# Recall Bulletin

## PRODUCT SAFETY RECALL

**SUBJECT:** Accelerator Pedal Sticking

**MODELS:** 2009-2010 Pontiac Vibe

**(1) Feeler Gauge (C) Clearance (2) Stopper (4) Housing**

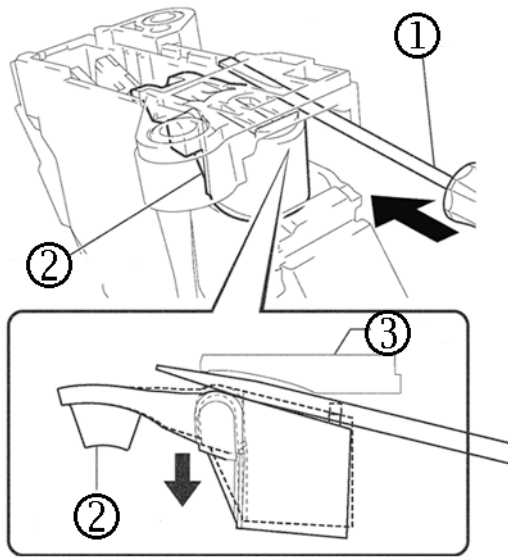
6. Determine the reinforcement bar thickness.

- 6.1. Using a feeler gauge (1), measure the clearance (C) between the stopper (2) and the housing (4).
- 6.2. Only insert the feeler gauge 10 mm from the end of the housing as illustrated.
- 6.3. Based on the measurement from Step 6.1, select the correct reinforcement bar using the table below.

Clearance	Reinforcement Bar	
	Thickness	Stamping
0.0 mm – 0.29 mm	1.4 mm	1.4 A
0.3 mm – 0.59 mm	1.6 mm	1.6 B
0.6 mm – 0.79 mm	1.8 mm	1.8 C
0.8 mm – 1.09 mm	2.0 mm	2.0 D
1.1 mm – 1.49 mm	2.3 mm	2.3 E
1.5 mm – 1.89 mm	2.6 mm	2.6 F
1.9 mm – 2.70 mm	2.9 mm	2.9 G
greater than 2.70 mm	Contact the Technical Assistance Center

2394597

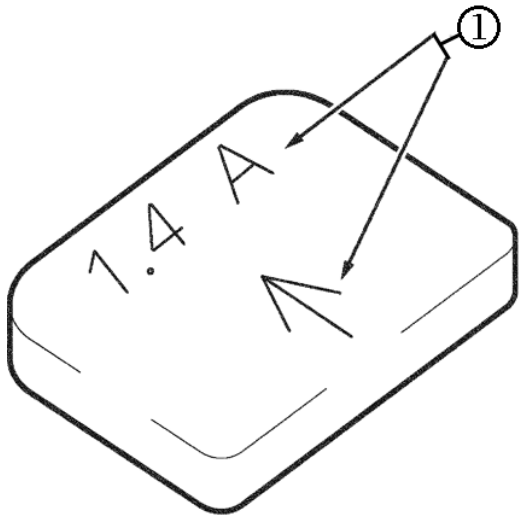
7. Install the reinforcement bar.

- 7.1. Insert a clean thin-bladed flathead screwdriver (1) between the housing (3) and the friction lever (2) until the friction lever lowers.

2394598

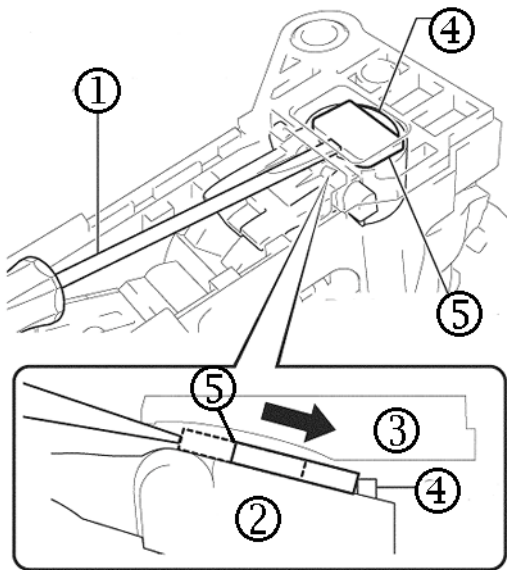
7.2. With the increased clearance between the friction lever (2) and the housing (3), insert the reinforcement bar (5) selected from Step 6.3.

2394600

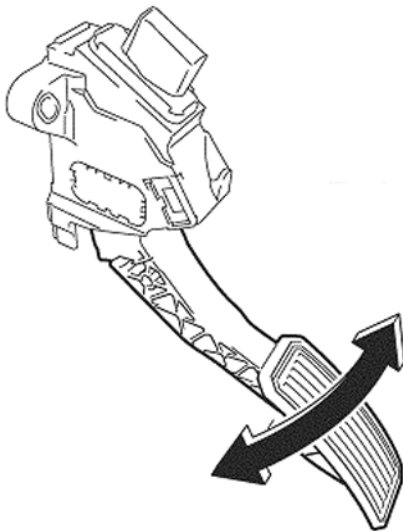
- 7.3. From the back of the pedal, firmly push the reinforcement bar (5) until it contacts the stopper (4).
- 7.4. Carefully center the reinforcement bar behind the stopper using a pocket screwdriver.

(A) OK (Centered) (B) Not OK (Not Centered)

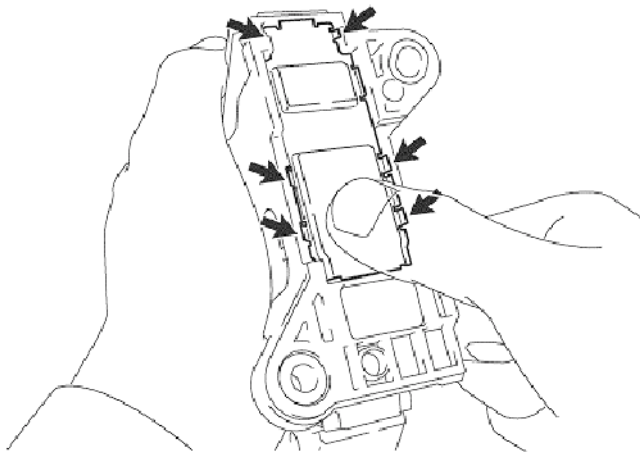
8. Verify that the reinforcement bar (5) is properly centered (A) and flush with the stopper.
